# METROPOLITAN GOVERNMENT OF NASHVILLE AND DAVIDSON COUNTY

## STAFF RECOMMENDATION 2104 Grantland Avenue July 15, 2015

**Application:** New construction—Detached accessory dwelling unit; Setback determination

**Description of Project:** Application is to construct a detached accessory dwelling unit (DADU) at the rear of the lot. The structure requires a rear setback determination.

Figure 4. The 1957 Sanborn Map shows outbuildings in the area located near or on the rear property line.

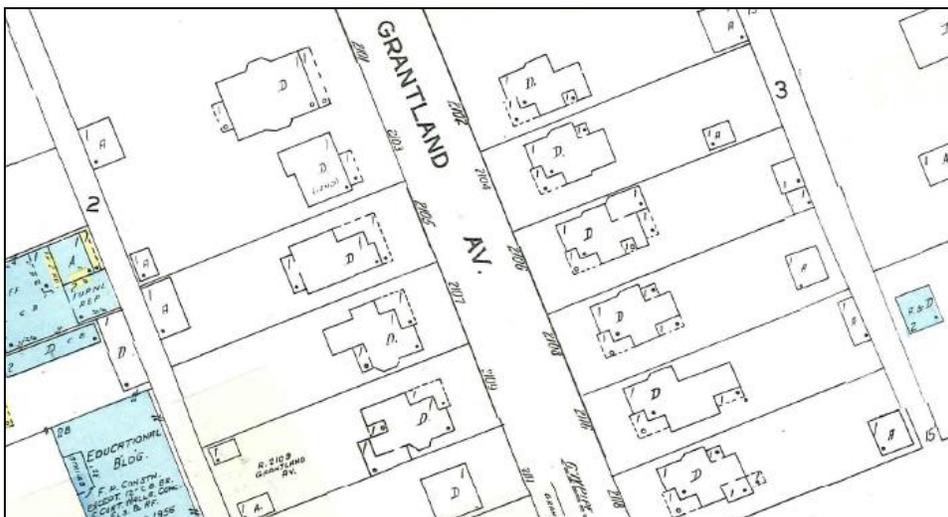
The new outbuilding does require a reduction to the rear setback. When an outbuilding has a footprint greater than seven hundred square feet (700 sq. ft.), base zoning requires that the structure be located twenty feet (20’) from the rear property line and five feet (5’) from the side property lines. In this instance, the structure is located at least five feet (5’) from the side property lines, but it is located just five feet (5’) from the rear property line. Staff finds the proposed rear setback to be appropriate for several reasons. In May 2014, the Commission approved a five foot (5’) rear setback for an accessory structure on this lot (that accessory structure was never built). Also, historically, outbuildings were located at the rear of the property, close to the rear property line. The 1957 Sanborn maps shows that many outbuildings historically abutted or were situated just a few feet from the rear property lines (Figure 3). A five foot (5’) rear setback is more historically appropriate than a twenty foot (20’) rear setback. In addition, the five foot (5’) rear setback allows for more space between the primary structure and the DADU. Staff recommends approval of the setback determination.
